**STAFF REPORT TO THE BOARD OF ARCHITECTURAL REVIEW
DEPARTMENT OF COMMUNITY DEVELOPMENT
Prepared November 30, 2021**

FILE NUMBERS: L19-0077 (Public Hearing Design Review)

REQUEST: Public hearing design review for a new three-story mixed-use building. The new building will be located to the north of the existing restaurant, which is proposed to remain. The new building is proposed to include one commercial tenant space, indoor recreation space, and a parking garage with 13 parking spaces and trash/recycling area on the first story. A total of nine dwelling units are proposed on the second and third stories.

Figure 10: Proposed Driveways

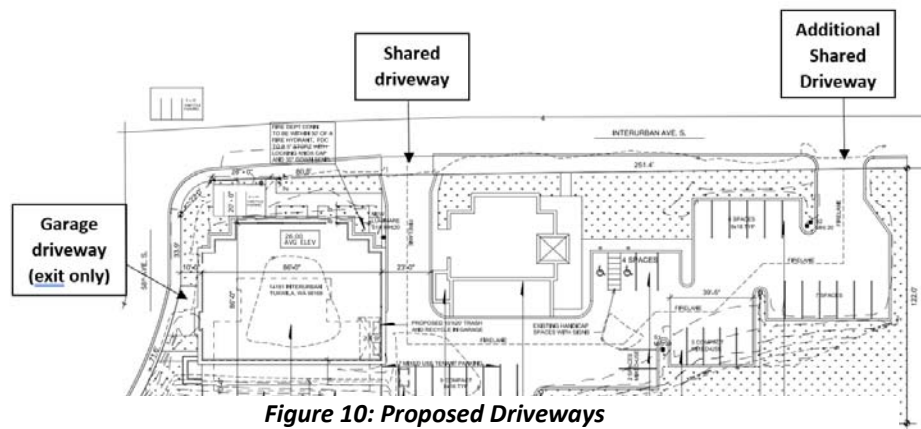
- The site design makes use of the existing driveways used by the restaurant. The project proposes to have the existing access off Interurban Ave S on the north side of the restaurant be a shared access and service drive located between the new building and the restaurant. The driveway off 58th Ave S

will be controlled access, with use limited to those who have garage openers (i.e., apartment residents and commercial tenants).

Figure 11: Site Design Transition from Public to Private Space

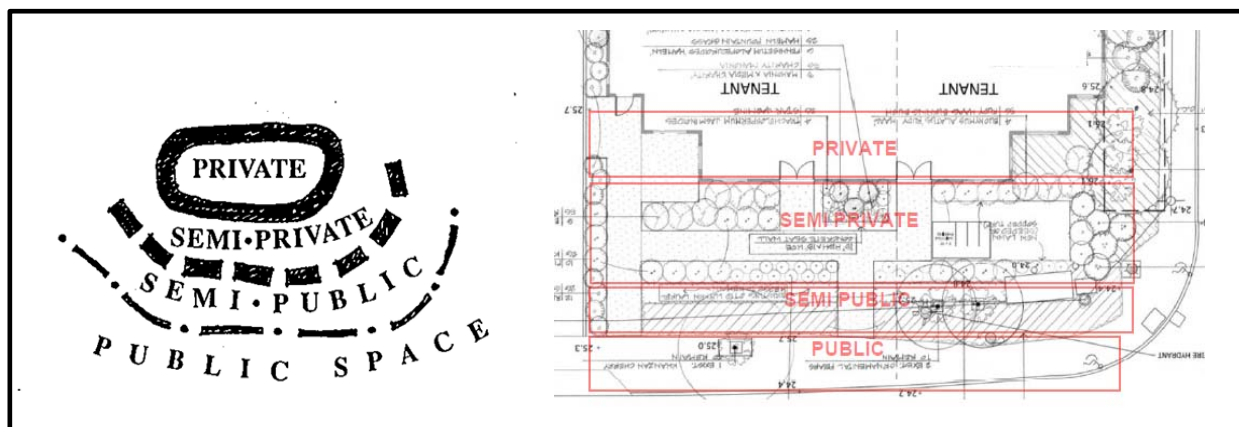
- The site design provides for varying degrees of privacy for the individual residents. The graphics below include a figure from the Multifamily Design Guidelines that illustrates how a site should be designed to provide physical cues indicating a transition from public to private space. The public, semi-public, semi-private, and private areas have been highlighted in the site plan in the graphic at right and are described below:

- Public: Sidewalks along Interurban and 58th Place S.
- Semi-Public: Landscaping at the back of sidewalk will consist of groundcover and shrubs in the area immediately adjacent to the sidewalk along Interurban, creating an open, semi-public transition to the site.
- Semi-Private: The existing hedge will remain on site and provides a symbolic barrier between the semi-public and semi-private space.

Figure 14: Building Colors and Materials

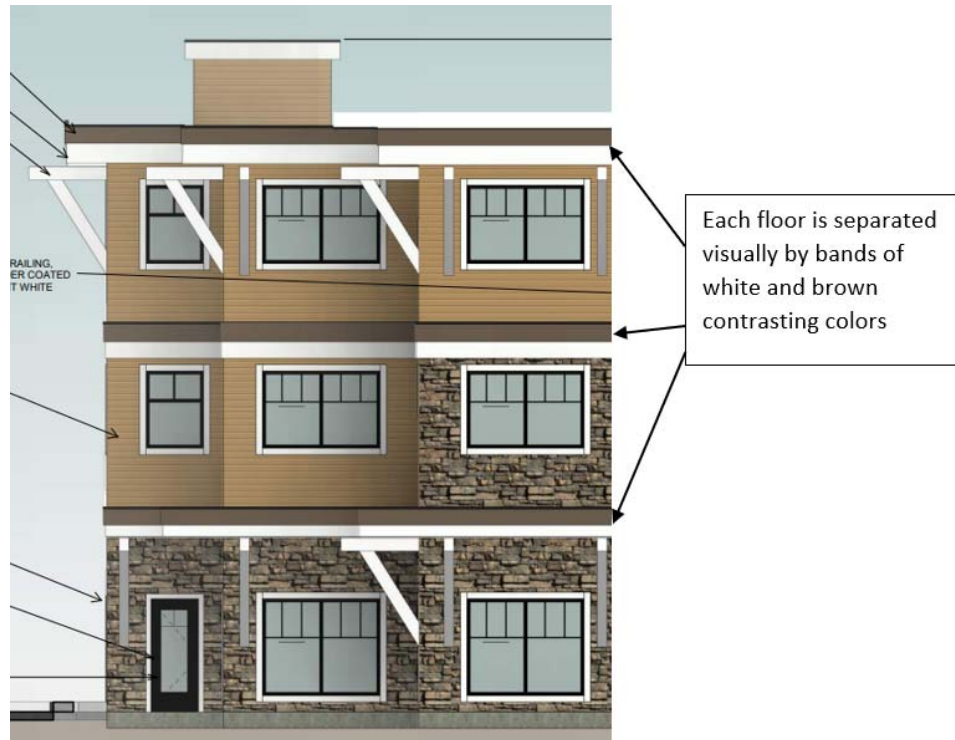
- Proposed building components, including windows, doors, corbels, the building parapets, decks, and railings are integrated into the overall building design through use of matching or complementary colors and materials to the main structure. Each floor of the building is visually separated by two horizontal bands made up of contrasting colors - a white (Chantilly Lace) color and a deep brown (Benjamin Moore North Creek Brown). The white color of the horizontal bands helps to accentuate white-colored building details which include trim around the doors and windows, corbels, and deck railings. The deep brown trim color matches the siding color used on the

ground floor. A lighter shade of brown (Benjamin Moore Deep Ochre) is proposed on the second and third floors. Stone veneer is proposed on the most prominent portions of the first floor facing Interurban Ave S and 58th Pl S and is carried up to portions of the second story. The stone veneer ties together the two shades of brown colors proposed for the siding and the dark brown color proposed for windows and doors (including the garage doors).

Figure 15: Tree Removal Plan

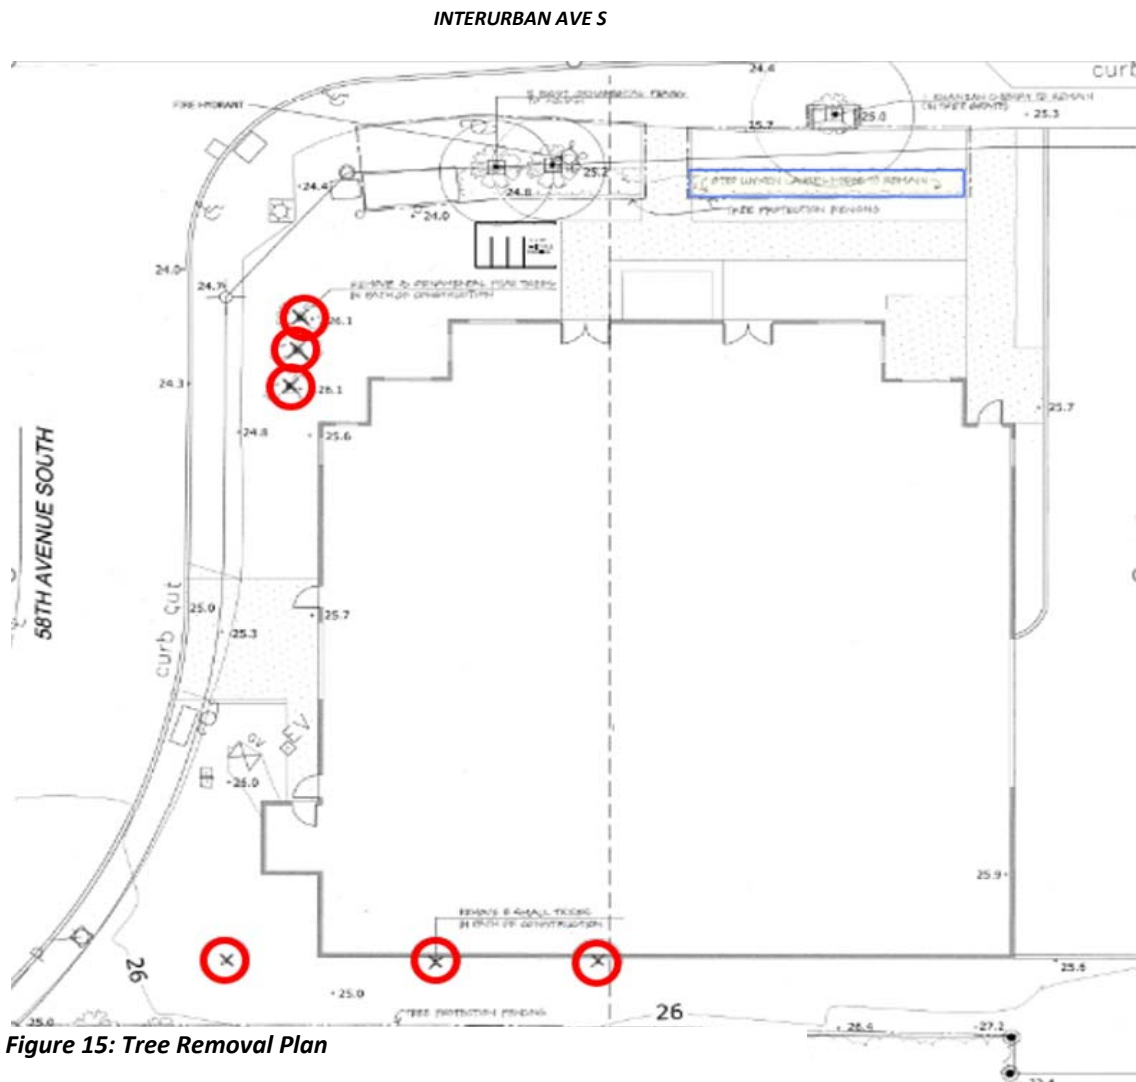
- Existing street trees and mature landscaping originally planted as part of the restaurant development is proposed to be retained to the extent possible. Figure 15 shows existing trees and vegetation on site. The trees proposed to be removed are indicated with red circles around them.

Sheet L1.2 of the landscaping plan set submitted for the project shows tree protection fencing along the inside of Mr. Galliano's property in vicinity of the project site. Two trees which appear to straddle the property line will remain and will be protected during construction. Mr. Galliano confirmed in responses to comments that "no hillside or tree cutting exists for this project."

Figure 16: Pedestrian Access

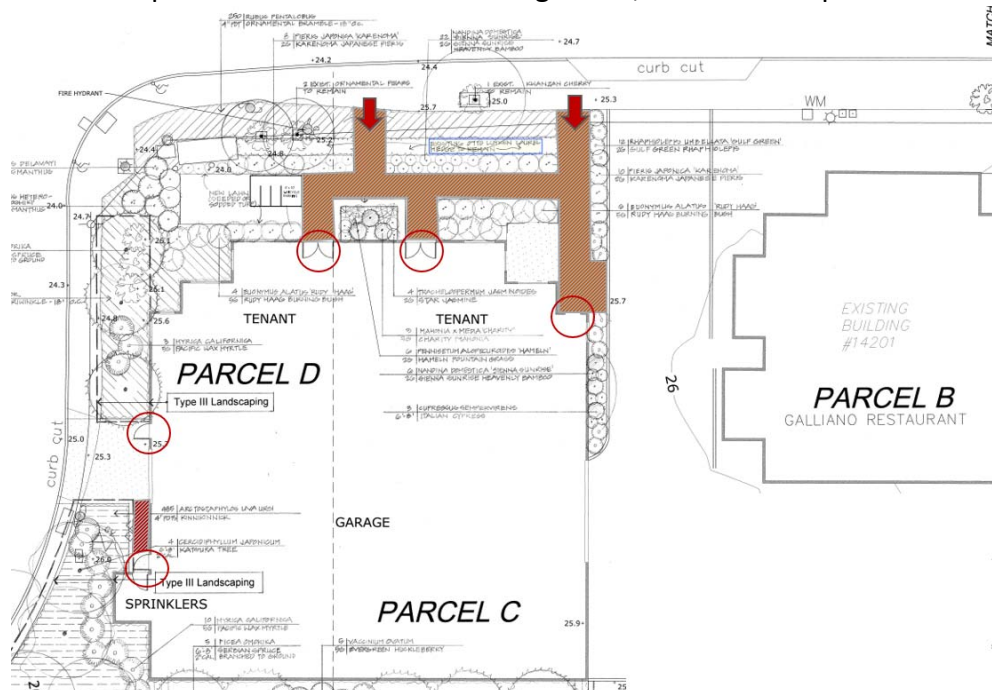
- Direct pedestrian linkages are provided from the sidewalk along Interurban Ave S to the front entrances to the tenant space, indoor recreation space, and the apartments. This is shown in Figure 16, where direct pedestrian

linkages from the sidewalks are shown with arrows, walkways are the shaded reddish/brown areas, and pedestrian entrances to the building are circled. Walkways are framed by landscape areas, and curbs are located along the driveways and drive aisle to prevent damage from vehicles.

Figure 17: Lighting Fixtures

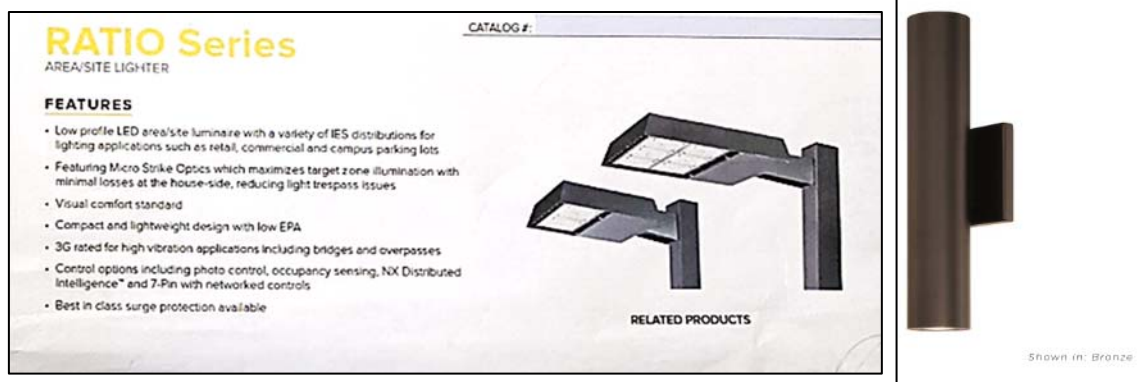
- A combination of building-mounted lighting and pole-mounted lighting is proposed, with high lighting levels proposed within the shared drive aisle and parking areas. This will promote safety in the surface parking area on the south side of the building, to be used by those apartment residents and commercial tenant occupants/visitors who do not have a dedicated space within the parking garage. The cut sheets below are the proposed light fixtures. The Tukwila Police Department reviewed the proposed lighting levels and agreed that lighting levels are high enough to promote safety according to Crime Prevention Through Environmental Design (CPTED) principles.
